Figure 12: Subject site as viewed from the front of OGH

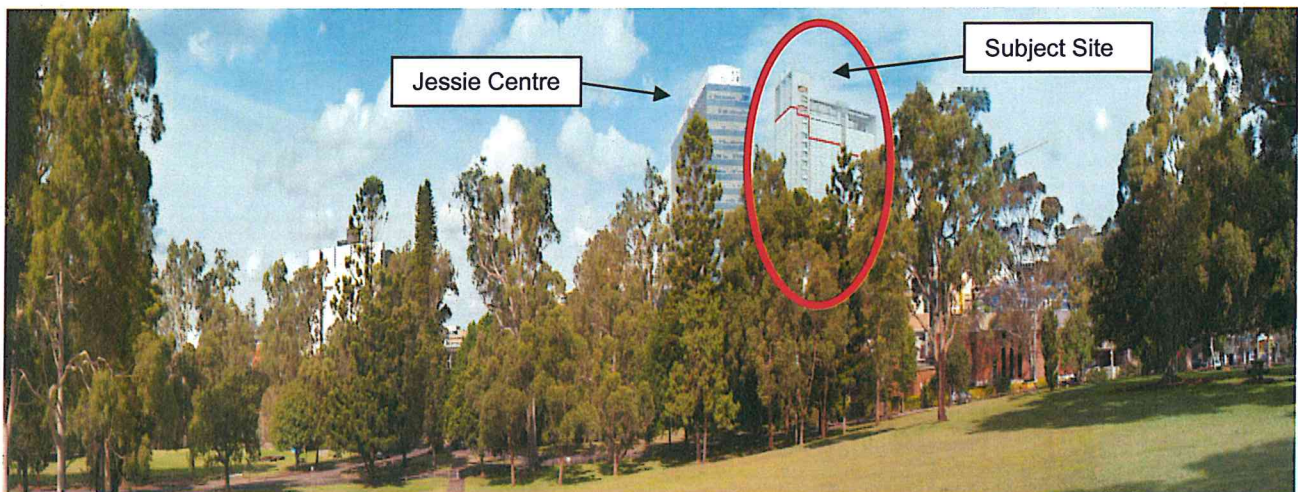
- The proposed development would be partially screened by existing vegetation at vantage point 1, located at the front of OGH;
- The proposed development would be visible from vantage point 2, located to the south-east of OGH, however, the additional development would be partially screened by existing vegetation

Figure 14: Subject site as viewed from the intersection of the Great Western Highway and Pitt Street
Note: Red line within the boundaries of the subject site indicates the extent of the approved building envelope

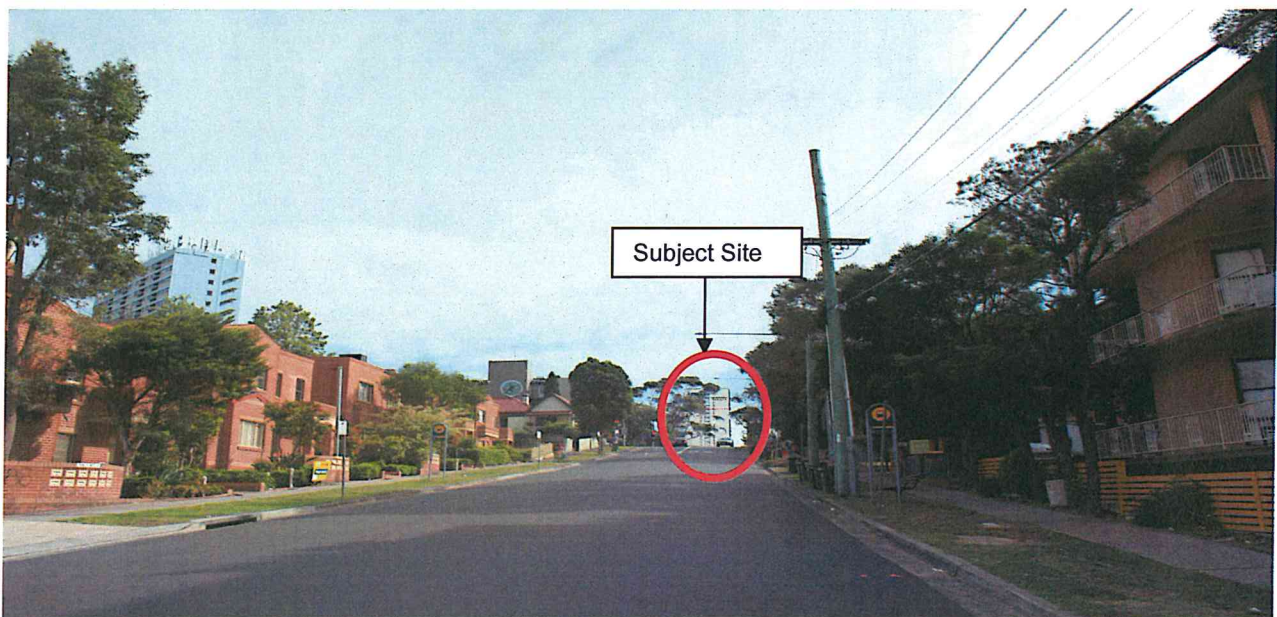
The department has assessed the proponent's view analysis in conjunction with the council and the Commonwealth Department of Environment and has concluded that:

- Given the height and scale of the existing developments within the residential area south of the Great Western Highway, potential view loss from within existing residential dwellings would be similar to that identified within the public domain. These impacts are considered

minor and acceptable on the basis that the application will not obscure views to any significant landmarks and will only result in the loss of views to a small portion of sky;

Figure 18: Comparison of approved and proposed configuration of archaeological display area

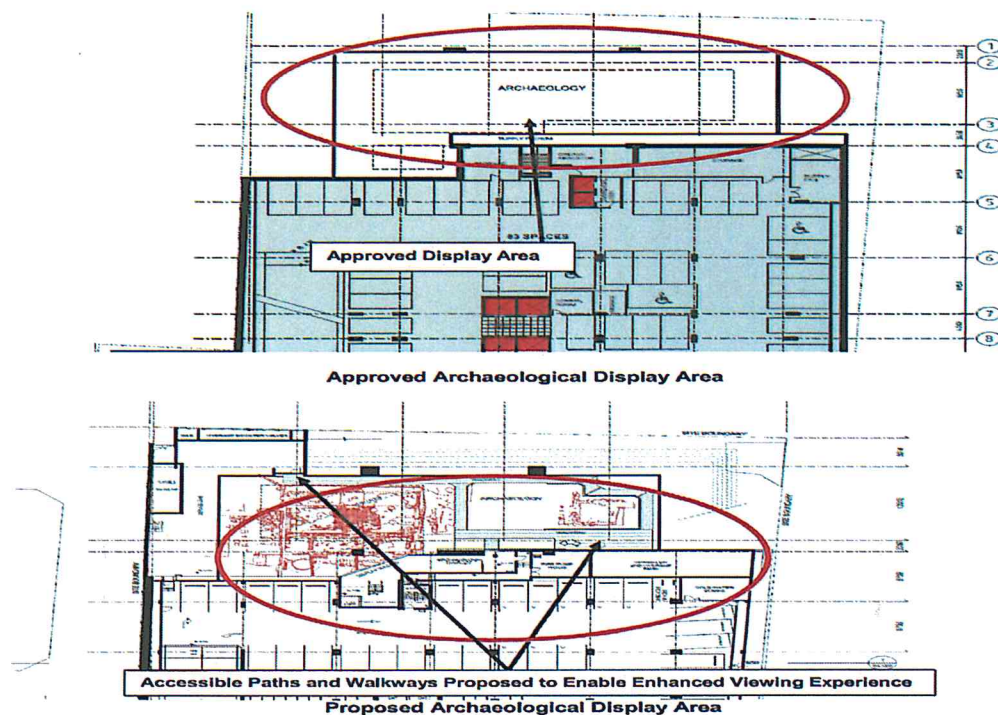
The department has assessed the impact of the proposed modifications to the archaeological display area and interpretation centre in conjunction with the Heritage Branch of the OEH and has concluded that the proposed modifications improve on the layout of the approved archaeological display area and will provide greater public access to the archaeological relics.

Notwithstanding the above, the department notes that a detailed schedule of materials and finishes for the walkways, balustrades and retaining walls within the archaeological display area is required. Furthermore, additional details are required in relation to the detailed design of the environmental management system to ensure the ongoing conservation of the archaeological relics. In order to address these issues the department has recommended conditions of approval to ensure that:

- The materials and finishes and the detailed design of the walkways, balustrades and retaining walls within the archaeological display area are undertaken in consultation with the Heritage Branch, OEH, and approved by the Secretary prior to the issue of a Construction Certificate for above-ground works; and

- The detailed design of the environmental management system is prepared in consultation with the Heritage Branch, OEH, and to the satisfaction of the Secretary prior to the issue of a Construction Certificate for above-ground works.
